Alert Service Bulletin

Title: Inspection and Replacement of Condenser Screen Mounting Screws

Applicability: Eurocopter EC145 Air Conditioning Systems

Figure 1
LH Aft Engine Fairing Looking Inboard

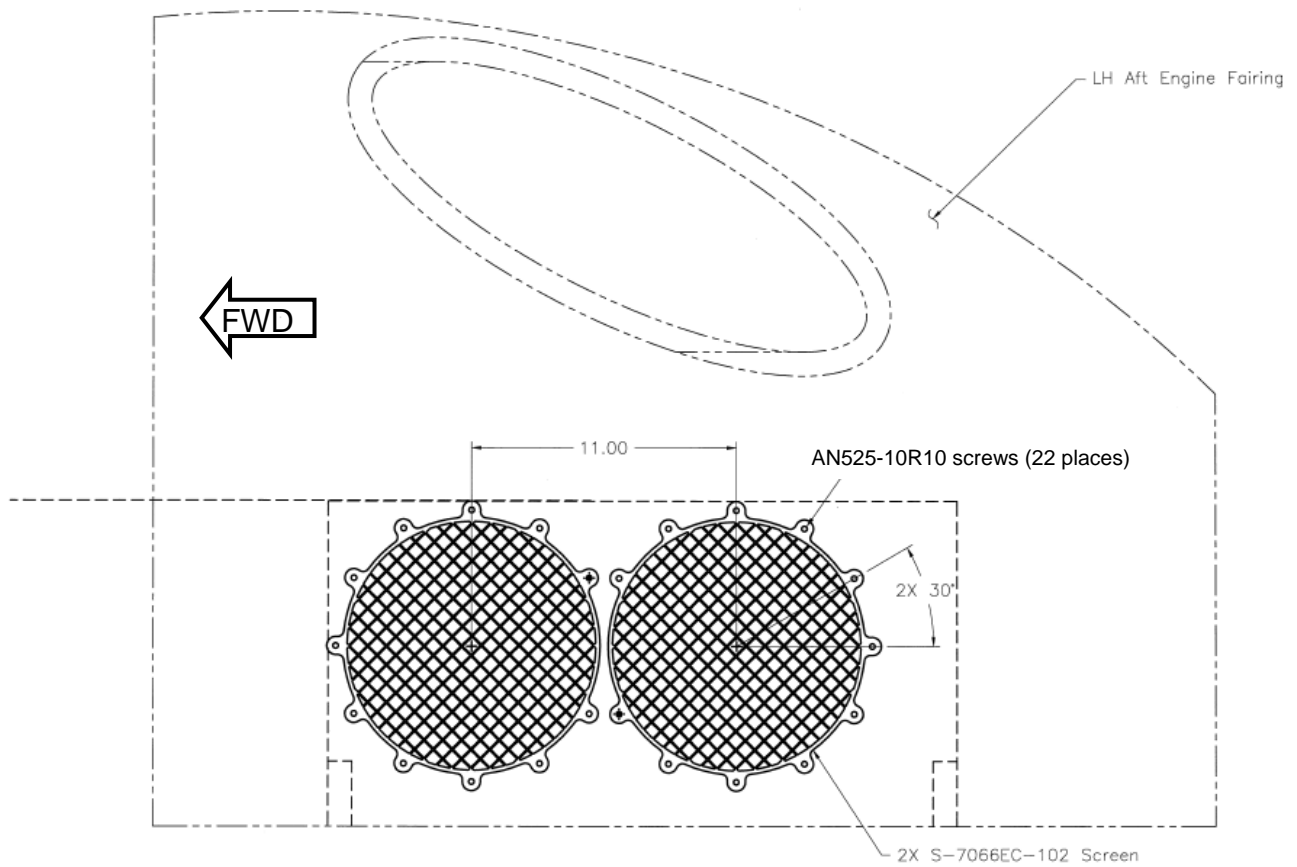
1. Remove AN525-10R12 screws from left S-7066EC-102 screen (11 places). Discard screws and retain screen for installation. Repeat for right S-7066EC-102 screen (11 places). See Figure 1
2. Install left S-7066EC-102 screen and AN525-10R10 screws (11 places). Repeat for right S-7066EC-102 screen and AN525-10R10 screws (11 places).
3. Inspect AN525-10R10 screws to ensure 1 thread minimum showing and clearance from the condenser housing.
4. Blend out scratches to the condenser non-structural enclosure as required. Maximum allowable scratch depth is 50% of the .040 inch wall thickness (.020 inches / 0.51 millimeters).
5. Apply surface protection to blended area as required. Reference Eurocopter document number HS7072-100 (Alodine and prime) or MIL-DTL-5541F.
6. Paint the protected surface to match surrounding area.
